# Service Bulletin

Category S	Applicable Model/s 1995 Millenia	Subject CUP HOLDER OPERATION	Bulletin No. 039/94
			Issued 12/23/94
			Revised

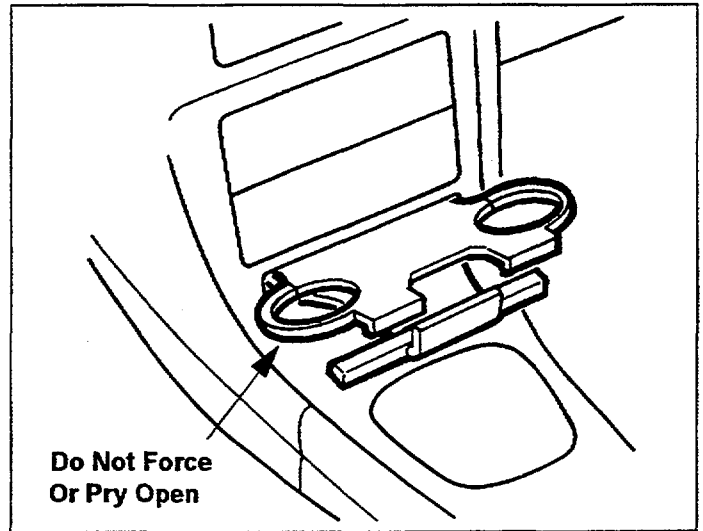
The cup holder may not open completely or may move roughly during operation. The configuration of the spring has been changed to improve the cup holder performance.

If a customer complains about the cup holder operation, remove the original cup holder and replace it with the modified holder.

1. Verify complaint.
2. Remove the center panel (p/n T002 55 210).
3. Remove the cup holder from the center panel and replace with a modified holder.
4. Install center panel assembly.
5. Verify repair.
